PLANNING REPORT

Architectural Review Board

COhatch - Riverview Village 25-045AFDP

Riverbank Decent

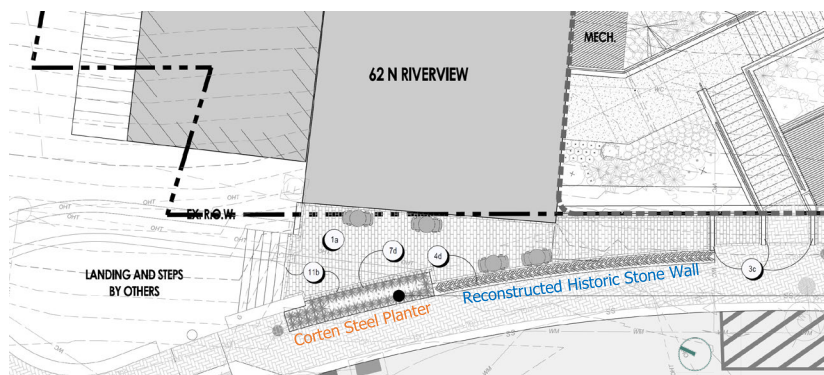
A preliminary design was presented during the FDP review for the area between the red cabin and the new building. The details have since evolved into a multifunctional design that accommodates service access to the middle level of the red cabin, ADA-compliant access

between the two buildings, a publicly-accessible patio, and connectivity to the future Riverside Crossing Park West paths and the historic ruins that will be maintained under the new building. The design includes a series of retaining walls and terraces, clad with a stone veneer. Two sets of stairs, placed at angles that maximize views of the Dublin Link bridge and the future park, are incorporated into the design. The set at the higher grade would consist of concrete steps with a stone-clad wall on each side. The bottom set would be closer to grade and consist of limestone steps and a stabilized crushed stone landing. All handrails and guardrails would be galvanized steel painted black with a design similar to that at the existing COhatch building. The flat surfaces forming the patio and service access would be paved with concrete.

A variety of landscape materials are proposed throughout the space and would also help screen mechanical equipment enclosures associated with the two buildings. They include deciduous and evergreen trees, flowering/deciduous shrubs, grasses, perennials, groundcovers, and vines. Stumps from some of the trees that were previously removed are also proposed to be incorporated into the space. LED tape lights are proposed to be incorporated into the stone caps along the stairs and patio, while LED uplights would highlight some of the stone walls and trees.

The overall design complements the setting and reinterprets in a creative way the historic terraces, steps and paths that historically extended between the red cabin and historic ruins.

Plaza

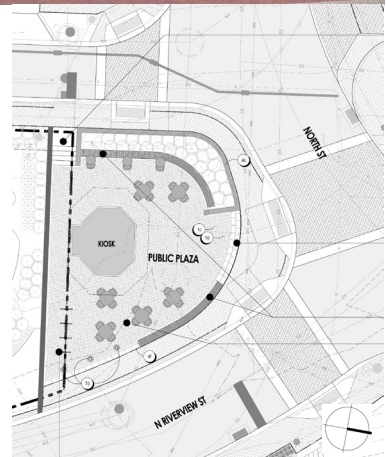
The overall design of the plaza at the north end of the site has remained the same, but some of the details have been enhanced. Refinements to the design of the surrounding streets have allowed the plaza to expand slightly to the west, creating a larger planting bed and more seating capacity. The stone walls on the north and south sides of the plaza now stairstep to provide more openness, while simultaneously offering protection/enclosure. Wood caps are proposed on several sections of the stone walls to accommodate additional seating. The steps leading into the plaza from the north have been widened to correspond to the width of a crosswalk that will link this space to the Dublin Link Bridge's West Plaza through a new path. A tree that was shown within the plaza at FDP has been removed due to conflicts with underground utilities, but an ornamental tree has been added to the widened planting bed.

There was uncertainty at the time of FDP approval as to whether the public streets were going to be paved with asphalt or brick pavers. For that reason, the applicant provided two paver color options for the plaza at that time. Given City Council's direction to use asphalt, the applicant is proposing dark red pavers consisting of an Endicott "Dark Ironspot" and "Medium Ironspot" blend.
